# **Recommendation on DS3 System Services Protocol – Regulated Arrangements**

DS3 System Services Implementation Project

June 12<sup>th</sup> 2020

Figure 1. Frequency vs expected response based on prorated and truncated methods

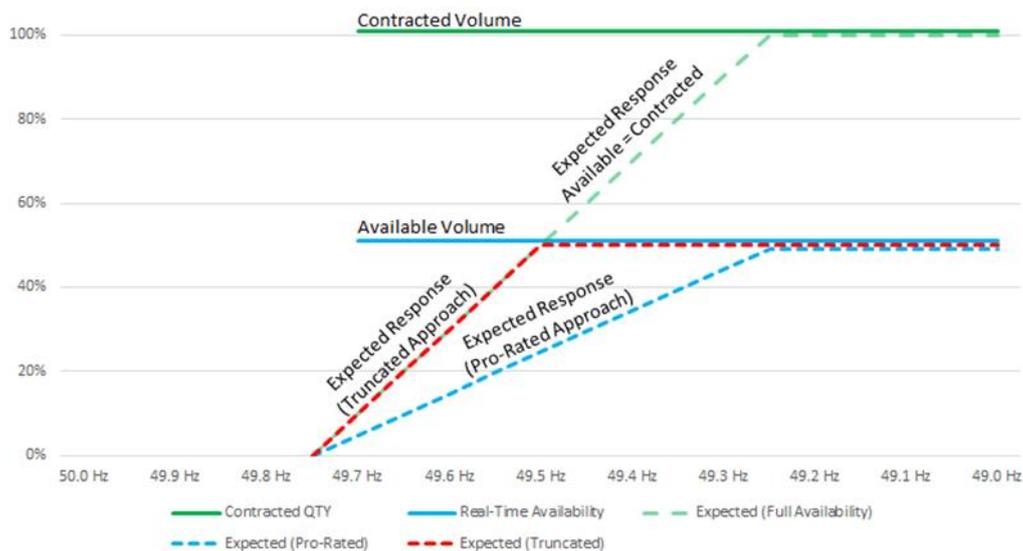
The DRAI has engaged with the TSO at length to highlight that the truncated methodology for assessing the provision of DS3 System Services by aggregated providers results in unresolvable technical constraints that will adversely affect aggregated unit types’ ability to maximise their contribution to DS3 System Services into the future. During these engagements, we have also highlighted that the prorated response characteristic of these unit types was clearly demonstrated to the TSO during the Qualification Trial Process and that the subsequent classification of these unit types as proven technologies was understood to be acceptance of their characteristics. In addition, our members have noted that this was detailed in their technical characteristics as described in their Technical Questionnaires and submitted as part of the DS3 System Services procurement process. As such, we believe that the proposed change to the DS3 Protocol document constitutes modification to the understanding under which volumes of DS3 System Services were contracted rather than a clarification.

The chart below depicts the profiles for prorated response and the proposed truncated response. When considering this issue, it is important to be aware that DS3 System Services payments are calculated on the basis of availability and not contracted values.

The key difference between these methodologies is:

- **Prorated** requires response to be linearly increased from 0% at  $F_{Start}$  to 100% at  $F_{End}$ . In the example below,  $F_{Start} = 49.7$  Hz and  $F_{End} = 49.3$  Hz. Importantly,  $F_{Start}$  and  $F_{End}$  remain consistent for each service (FFR, POR, SOR, TOR1) which allows individual providers within an aggregated unit to additively increase the volume they make available to each service by distributing the trigger frequency for each underlying provider depending on the first reserve service they provide.

- **Truncated** also requires response to be linearly increased from 0% at  $F_{Start}$  to 100% at  $F_{End}$ ; however,  $F_{End}$  will vary for each service based on a unit's real-time availability of that service versus the contracted value. For example:
  - If FFR-contracted is 10 MW and FFR-available is 10 MW (100%) then  $F_{End} = 49.3$  Hz
  - If POR-contracted is 20 MW and POR-available is 10 MW (50%) then  $F_{End} = 49.5$  Hz

The TSOs understand that centralised control with more complex logic may be required in order for PPMs and aggregated units to provide a truncated response characteristic when declared to a lower availability. However, we believe that the clarification to the protocol is required, as it is not currently appropriate for the TSOs to continue to procure, or utilise services from providers with variable or uncontrolled MW/Hz or percentage droop response characteristics.

The TSOs acknowledge that more sophisticated control logic may be required in order for PPMs to provide dynamic service provision. In addition, for aggregators to provide either a static response with multiple steps or indeed a dynamic service when the units are not fully available may well require compromising across service provision. To the extent we need to define a service in detail it may inadvertently remove some of the choice a provider might have. This balancing services definition for system security to the degrees of freedom a provider has in supplying a service is something that will be at the core of the future system services arrangements for 2030. However, notwithstanding this concern, we believe it is appropriate for this clarification at this time.

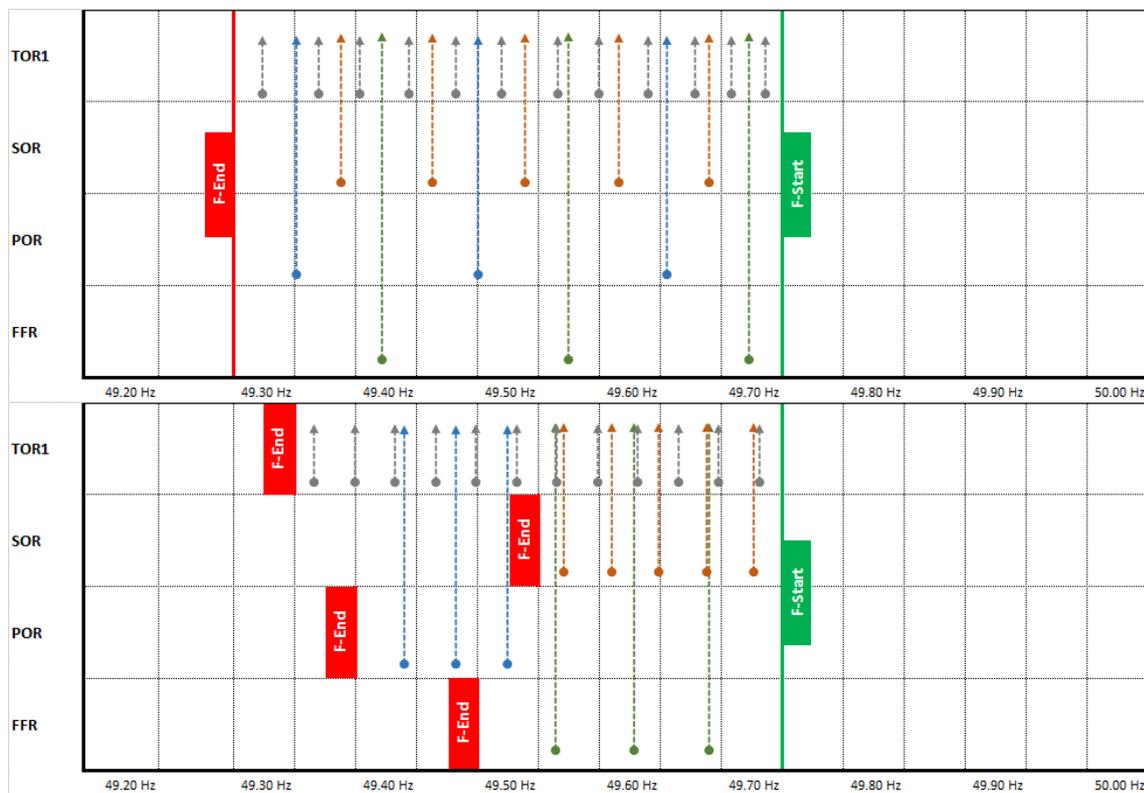
In contrast, this has a significant effect on aggregated units where the availability of individual underlying participants, each of which start to respond in different DS3 System Service reserve intervals, varies considerably, causing a substantial difference in the unit's proportional availability for each service when compared to its maximum contracted volume for that service. This leads to unsolvable optimisation constraints that adversely affect the provision of these services.

A number of our members delivering DS3 services employ sophisticated algorithms that update the trigger frequencies of each element of their unit in proportion to the element's availability, in real-time, in order to provide a linear response that is proportional to a frequency delta. Every effort has been made to support the TSO's proposal for the use of the truncated method; however, our members have concluded that the only way to adhere to this method is to substantially reduce the volumes that are contracted for each service and then exclude any volumes that are available in real-time that are in excess of the contracted volume. While this would produce a response profile shape that is similar to what is sought by the TSO, it will ultimately reduce
